Access Compliance Report

Public Rights-of-Way

(Curb Ramps)

Intersection ID: 3097	Main Street: PLACER_MAPLE_LN	Cross Street: ALLEN_A_BROWN_RD	Location: NW
ADA ID: 13A45B809F58	Ramp Type: PerpDiag	Initial Pass/Fail: Fail	Overall Compliance: No
Severity Score: 10			
Codes/Mitigation Info/Possible Solution		Field Measurements/Component Compliance

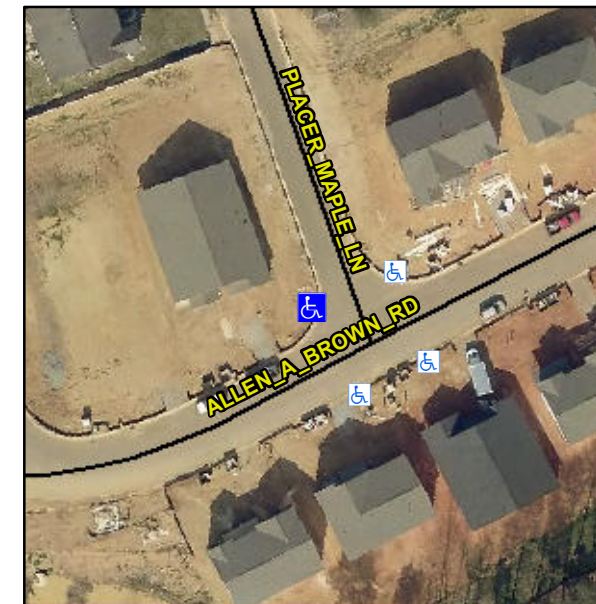
Not Found, R304.5.1, R304.5.3

Compliance	Description	Data	Compliance	Description	Data
N/A	Ramp Length (in)	50.0	Yes	Ramp Slope (%)	7.8
No	Ramp Width (in)	47.0	No	Ramp XSlope (%)	4.0
N/A	Flare Type LT	N/A	N/A	Flare Type RT	N/A
N/A	Flare Slope LT (%)	N/A	N/A	Flare Slope RT (%)	N/A
N/A	Flare Traversable LT?	N/A	N/A	Flare Traversable RT?	N/A
N/A	Landing Length (in)	N/A	N/A	DWS Provided?	N/A
N/A	Landing Width (in)	N/A	N/A	DWS Contrast?	N/A
N/A	Landing Slope (%)	N/A	N/A	DWS Length (in)	N/A
N/A	Landing X Slope (%)	N/A	N/A	DWS Full Width?	N/A
N/A	Landing Curb? (Y/N)	N/A	N/A	DWS Offset (in)	N/A
N/A	Shared Landing?	N/A			
N/A	Gutter Ponding?	N/A	N/A	Gutter Slope (%)	N/A
N/A	Gutter Lip Ht (in)	1.0	N/A	Gutter X Slope (%)	N/A
N/A	Painted X Walk1?	No	N/A	Painted X Walk2?	No
	X Walk 1 Direction	To S		X Walk 2 Direction	To E
N/A	X Walk 1 Width (in)	N/A	N/A	X Walk 2 Width (in)	N/A
	X Walk 1 Slope (%)	0.8		X Walk 2 Slope (%)	6.9
	X Walk 1 X Slope (%)	6.6		X Walk 2 X Slope (%)	0.9

N/A	Ramp inside XWalk1?	N/A	N/A	Ramp inside XWalk2?	N/A
	Road Slope (%)	4.9	N/A	Clear Space?	N/A
	Road X Slope (%)	5.4	N/A	Clear Space to XWalk (in)	N/A
N/A	Any Obstructions?	N/A	N/A	Storm Grate/Utility Hazard?	N/A
	Obstruction Type			Storm Grate/Utility Type	
		N/A			N/A
		Yes		Surface Condition? (G/P)	Good

Remove & Replace Curb Ramp With Two New Directional Ramps or Equivalent.
